PLANNING COMMITTEE – 22 January 2026

24/2073/OUT - Outline Application: Development of up to 600 residential dwellings (Use Class C3(a)), construction of a 5-bedroom property for childrens social care and supported living (Use Class C3(b)). Two vehicular access points from Little Green Lane and further pedestrian / cycleway accesses. A one form entry primary school (Use Class F1(a)) (plus expansion land for a two form entry primary school). A mixed use local centre including provision for NHS health and social care services (Use Class E(e)), community building (Use Class F2), retail and cafe provision (Use Class E(a-c)), car parking and associated infrastructure. A country park, areas for play and recreation, allotments, community orchard and landscaping with associated infrastructure including sustainable urban drainage systems. (Layout, scale, appearance and landscape as reserved matters) at LAND TO NORTH OF LITTLE GREEN LANE, CROXLEY GREEN, WD3 3SP

Recommendation: The APPLICATION BE DELEGATED TO THE HEAD OF REGULATORY SERVICES TO GRANT PLANNING PERMISSION 24/2073/OUT following the completion of a S106 Agreement to secure the Heads of Term set out at section 7.20 below and subj

Planning Obligation

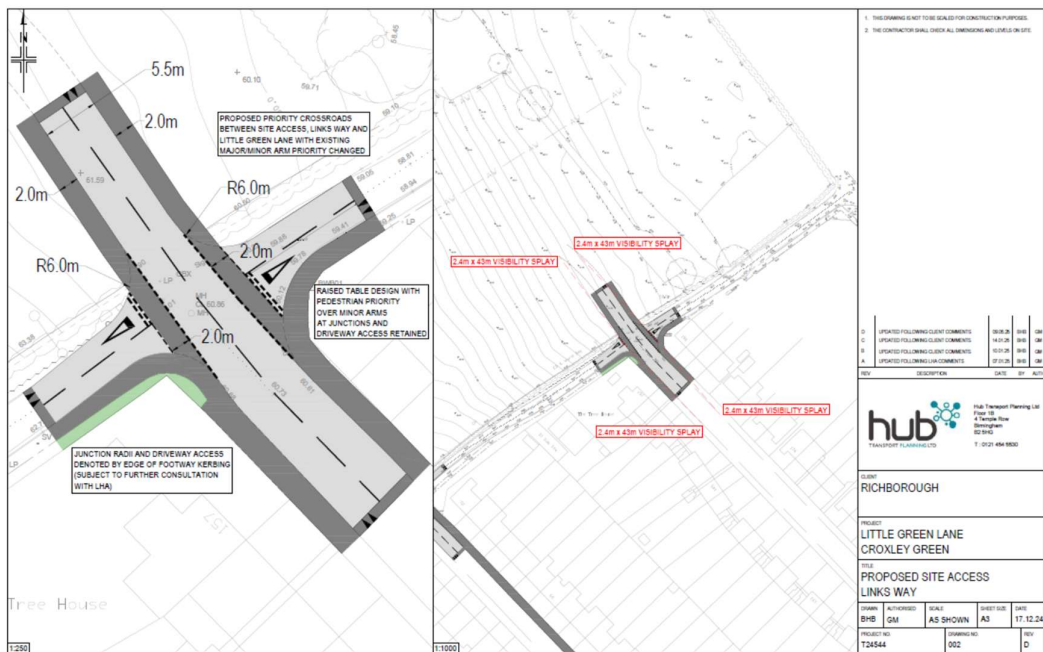
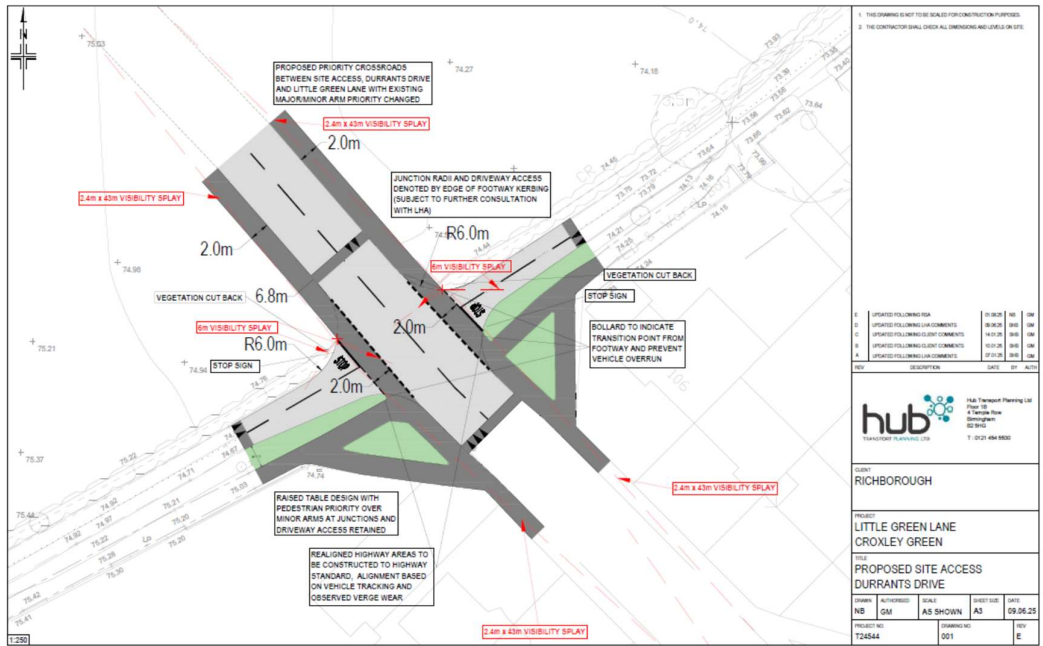
A proportion of the residual Strand 2 financial contribution towards improving walking and cycling environment will be used for the delivery of wider 20mph speed limit covering residential area to west of site. The contribution to be used to design, consult and implement Croxley Green 20mph zone.
